STATE OF MAINE  
DEPARTMENT OF HUMAN SERVICES  
AUGUSTA, MAINE 04333

Re: Gary Hilliard Property, Townsend Road, Augusta

Subject Gary Hilliard Property, Townsend Road, Augusta

Subject: New System Variance to the Maine Subsurface Wastewater Disposal Rules, Hilliard property, Townsend Road, Augusta

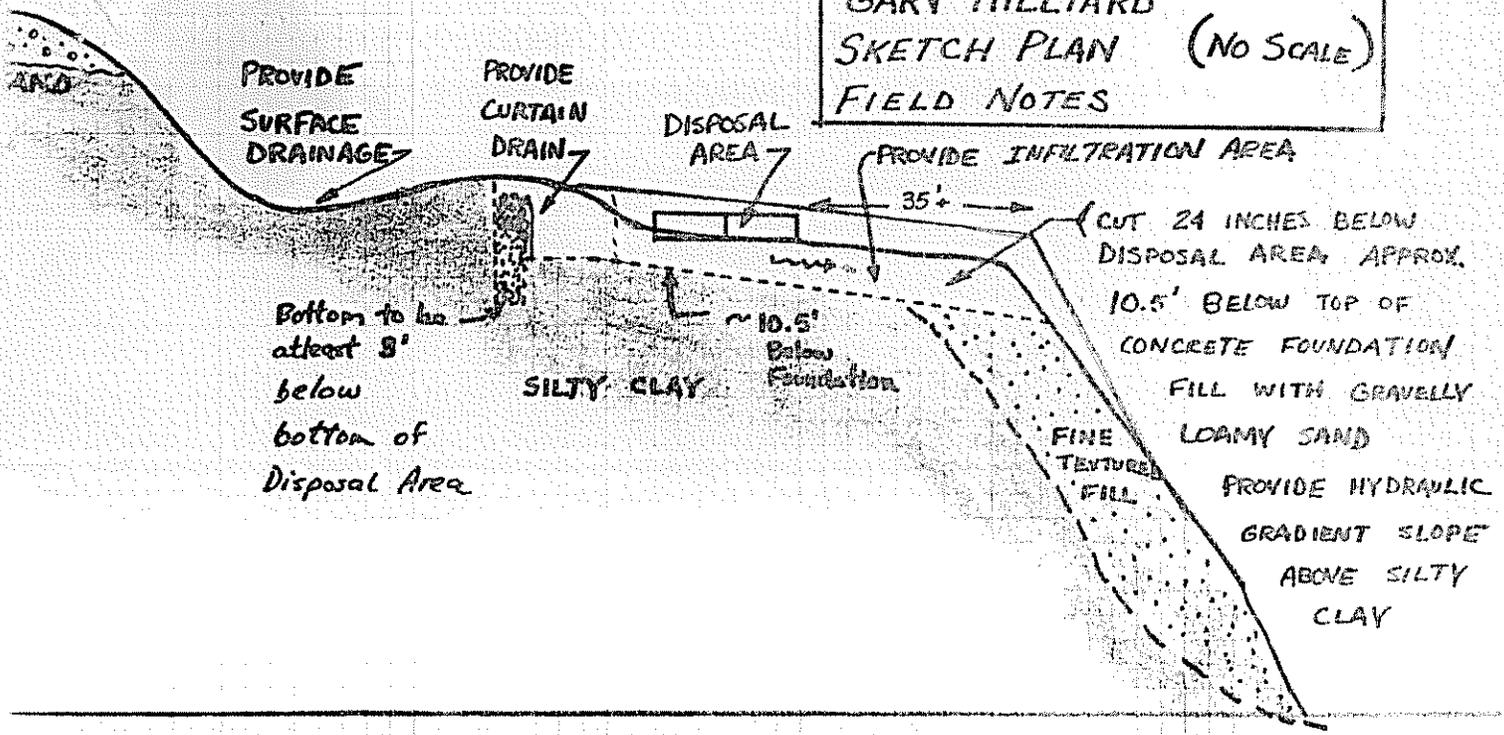
Jay Hardcastle and I met with Gary Hilliard, Richard Baker, LPI, and William Rideout, S.E. on September 4, 1981 to review the disposal site. The chambers had been removed from the site and only the septic tank remained.

Based on the existing conditions, the following were concluded on-site:

1. The area that the chambers had been installed in is the best location, all things considered.
2. The disposal system installation will require a New System Variance based on at least the present conditions.
3. Extensive site preparation will be necessary to rework the area.
4. William Rideout will be available to guide and inspect the site work.
5. Richard Baker will be on-site to observe the installation.
6. The infiltration area will be sized to accomodate the hydraulic conductivity of the original silty clay subsoil (Profile 9). William Rideout will calculate the disposal area size after he specifies the fill texture.

Subsurface Wastewater Disposal Plan

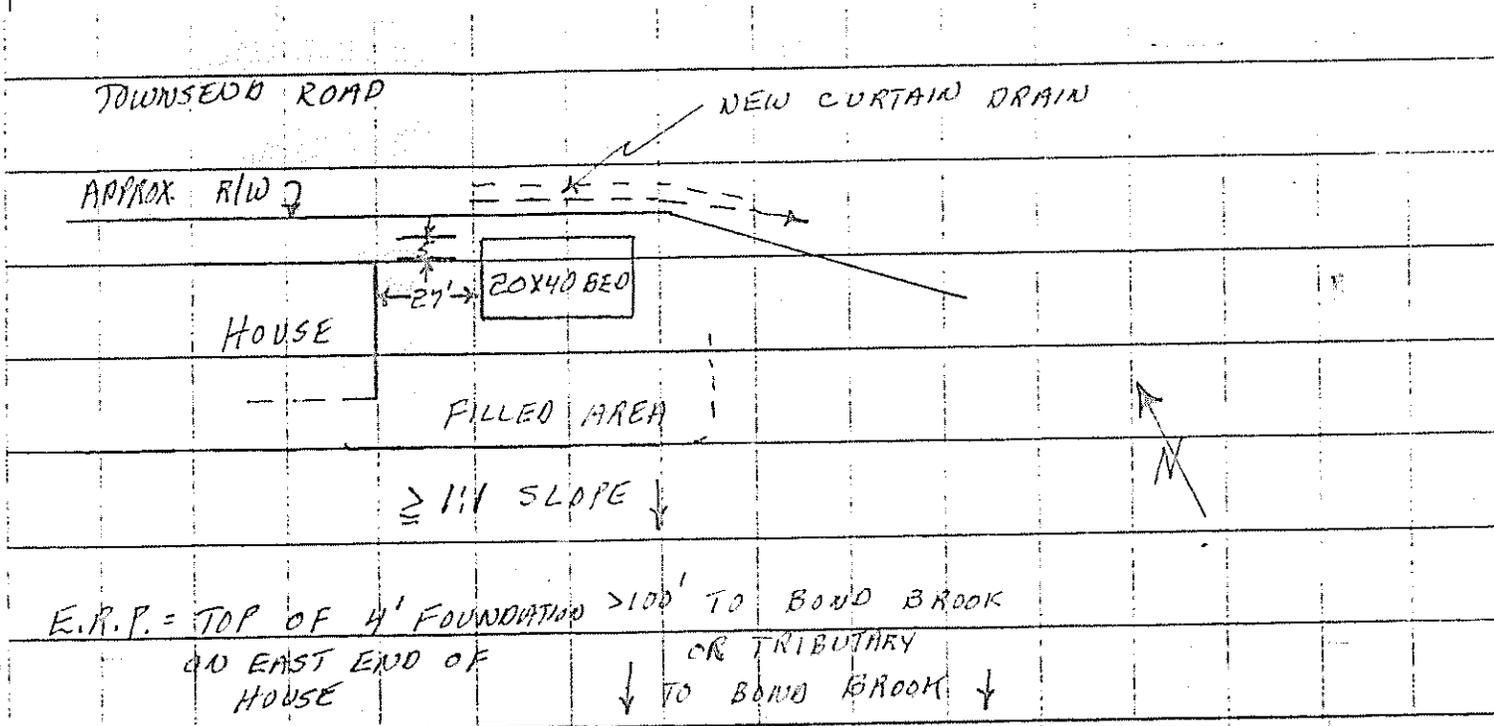
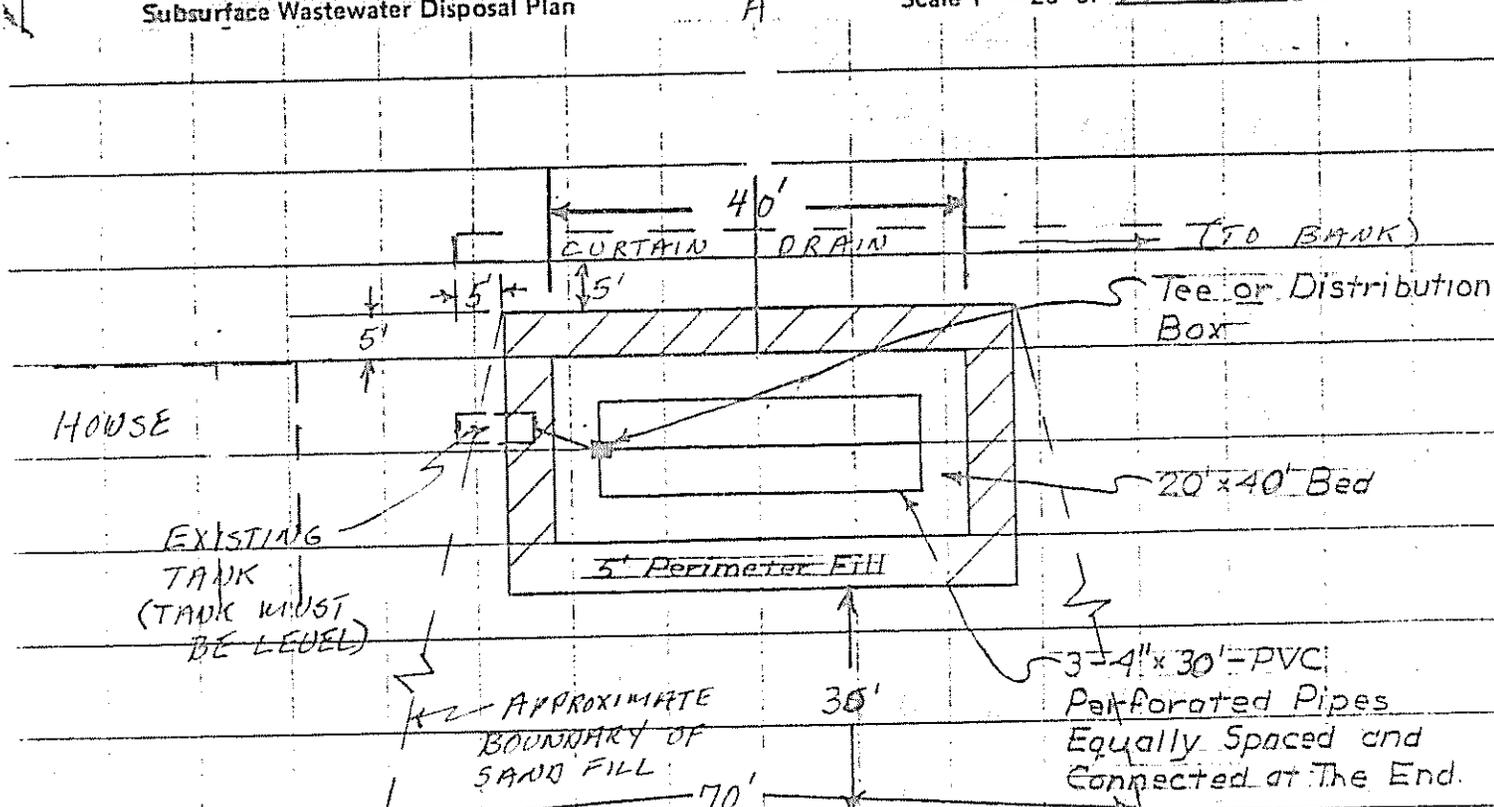
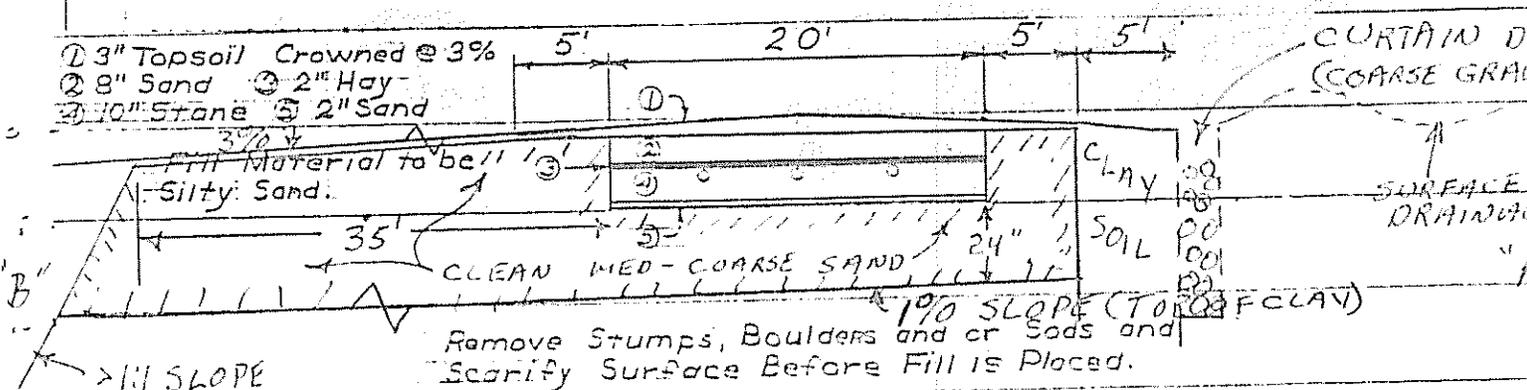
The proposed system has been designed based on a design flow of 300 gallons per day. In addition, the disposal area has been sized on the square footage for the medium coarse sand fill material in which it will be placed. The square footage of the sand fill material has been based on the original clay and will provide approximately 2100 square feet. In addition, a curtain drain will be provided upslope diverting any laterally moving waters to an existing diversion ditch to the southeast of the proposed bed.

The installation of a 1000 gallon septic tank followed by a 40'x20' bed system located in approximately 4 feet of clean medium coarse sand fill with the dimensions of approximately 50 feet in length by 70 feet in length by 60 feet in width.

The amount of fill required on the upper slope and downslope sides shall be as shown on the cross-section on the HHE-200 Form dated September 9, 1981.

In consideration of the HHE-200 Form dated September 9, 1981, along with the recommendations and justifications noted on the HHE-215 Form, this office hereby grants the responsible local plumbing inspector the authority to waive certain provisions of the Subsurface Wastewater Disposal Rules, for the following new disposal system under the authority of Section 16.A of the Rules.
